REMARKS/ARGUMENTS

FIG. 6

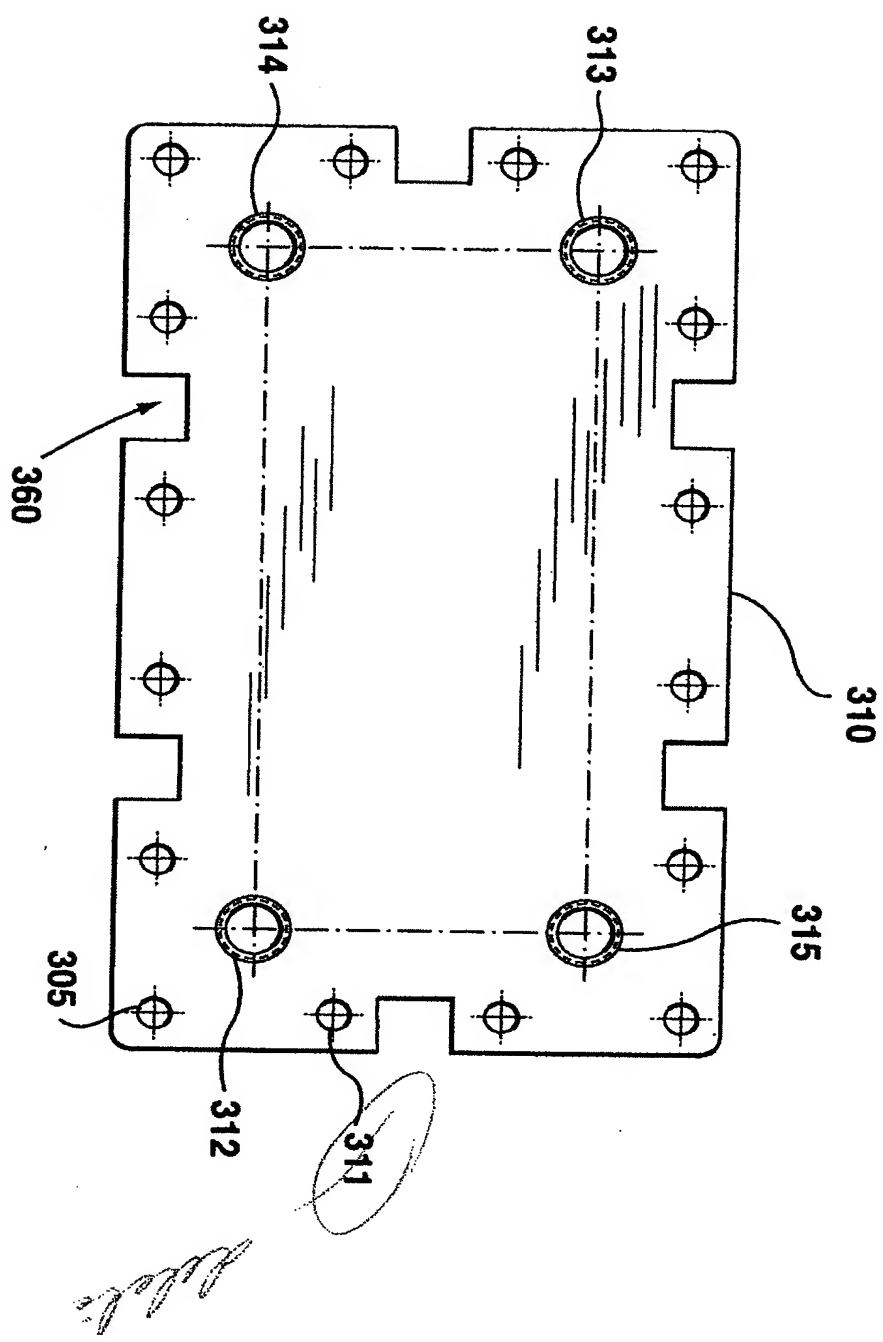
With respect to the objection to the drawings, under the same rule, the Examiner noted references 116 and 118 in Figure 1a and 311 in Figure 6 that were not apparently referred to in the specification. The specification is being amended to refer to references 116 and 118; Figure 6 is being amended to delete the reference to reference 311.
